525 WEST BROADWAY (COMPLETE AFTER  
PRELIMINARY APPLICATION)  
DE408752 - ZONE C-3A

**DEVELOPMENT PERMIT STAFF COMMITTEE MEMBERS**

October 26, 2005/November 9, 2005

Figure 1 From Central Broadway C-3A Urban Design Guidelines

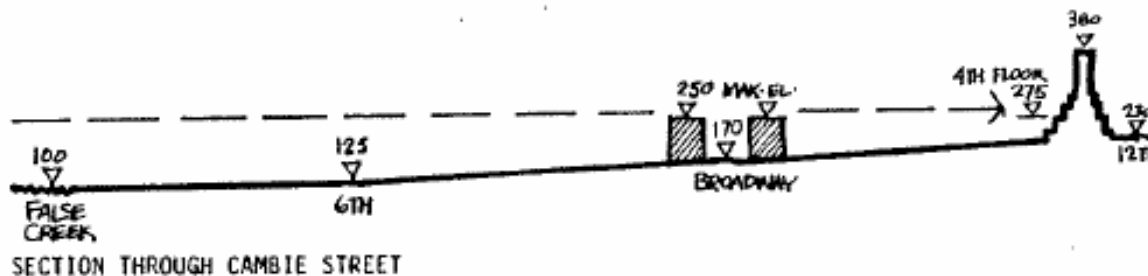
View Cone 9.1 restricts the height over the southeast corner of the site on Broadway to approximately 80 ft. (24.5 m).

- 1.1 design development to reduce the maximum elevation of the building, including the mechanical penthouses, to meet the Central Broadway C-3A Urban Design Guidelines elevation of 250 ft. and provide detailed height calculations;
